QUALITY ASSURANCE -- NON-CONFORMANCE REPORT

Report No: NCR-000777

Component: FB3126A Floorbeam on Lift 13AE

Reference Description: Heat Straightening without Engineer's Approval

Component: FB3126A Floorbeam on Lift 13AE

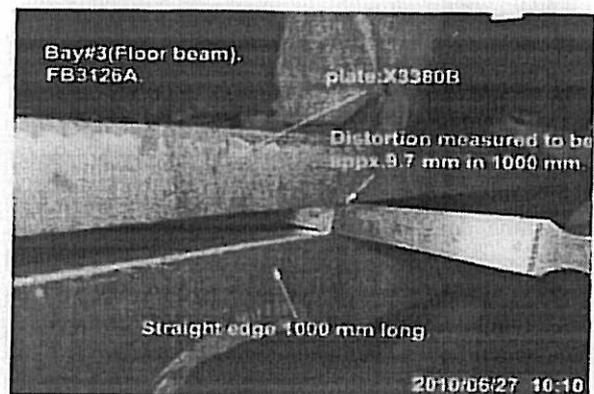
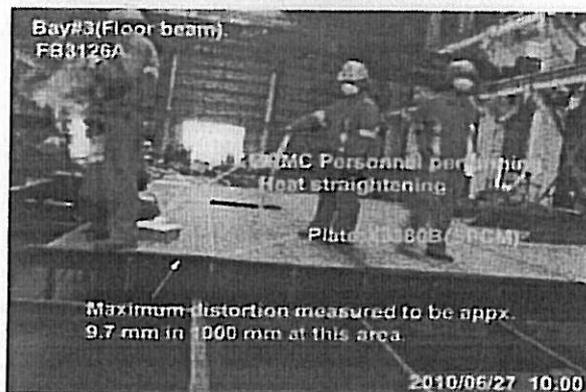
During the Caltrans Quality Assurance in-process observations of the fabrication of Floorbeam FB3126A, QA discovered the following issue:

- ZPMC personnel heat straightening Seismic Performance Critical Material (SPCM) material distorted by welding without the Engineers approval.
- The Floorbeam is identified as FB3126A.
- The plate is identified as X3380B (SPCM).
- The deviation from flat as measured by this QA was 10mm per 1000mm.
- The Material thickness is 20 mm.

AWS D1.5/2002 Section 3.7.3: "Members distorted by welding shall be heat straightened by mechanical means or by carefully supervised application of a limited amount of localized heat as approved by the engineer".

Caltrans Special Provisions Section 8-3: "For material more than 16 mm, the Contractor shall not heat straighten members more than 3 in 1000 without prior approval of the Engineer".

Heat Straightening Record(HSR1)

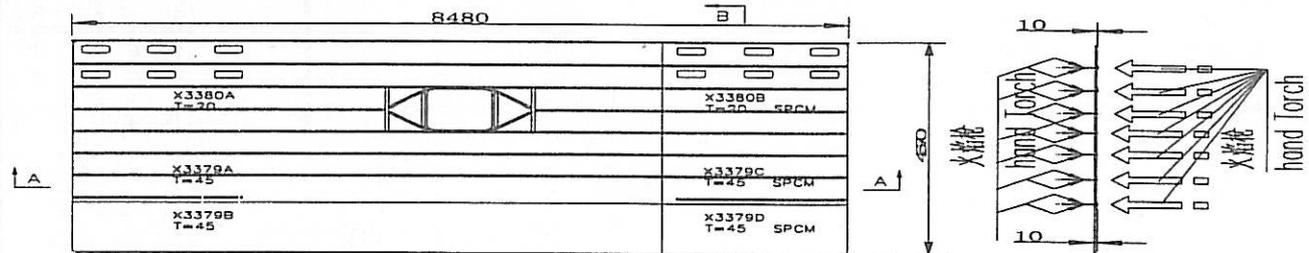
After finishing heat straightening, the weld of the heat area shall perform NDT according to the approved shop drawing 校火后, 根据图纸要求对热影响区域进行 NDT 检测

Control current, voltage and weld speed according to relevant WPS. If necessary anti-deformation or hold down device can be added. 依据相应的WPS的要求控制电流, 电压和焊接速度. 如有必要, 可使用反变形设施进行校正.
